Forward Endcap EMC Mechanics Issues

PANDA Collaboration Meeting 18/1, GSI, March 6, 2018

Disk DIRC Cabling Conflicts

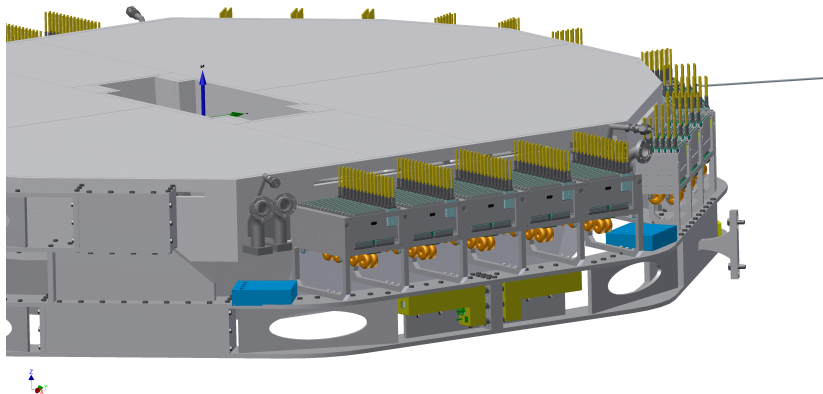
- Query from Disk DIRC people on modification of SADC crates

■ Suggestions made by Disk DIRC group (Erik)

- previously the plan was to place the HV-dividers which do not fit on top of a ROM further outside in the region with 242 mm space along z
- new constraints take away large regions also for guiding cables and cooling
- more space is needed for the EDD!

ruled out by EMC group

Disk DIRC Cabling Conflicts

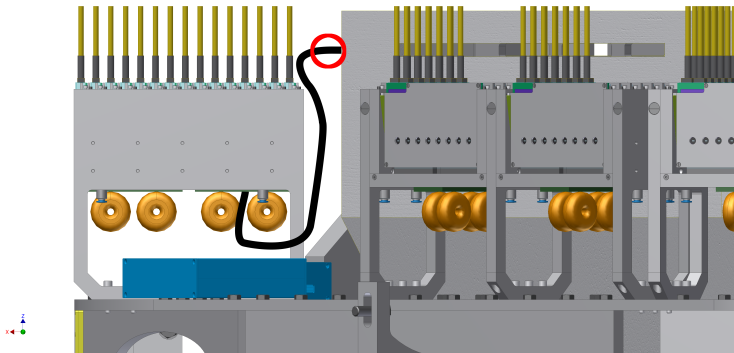
- All space behind SADC backplane PCB needed for cabling (occupied, mountability)
- SADC crate height corresponding to electronics frame cable outlet (bending radii, stiff glued section)

Disk DIRC Cabling Conflicts

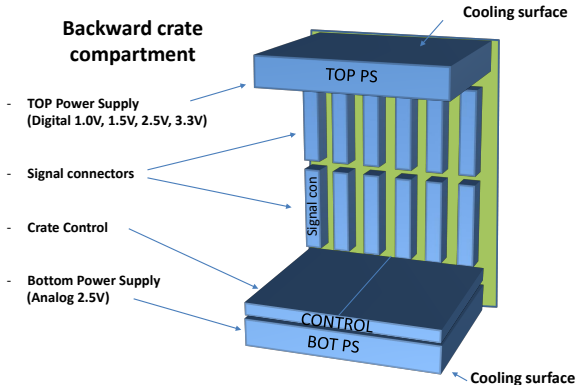
- More realistic occupancy of SADC crate backplane space
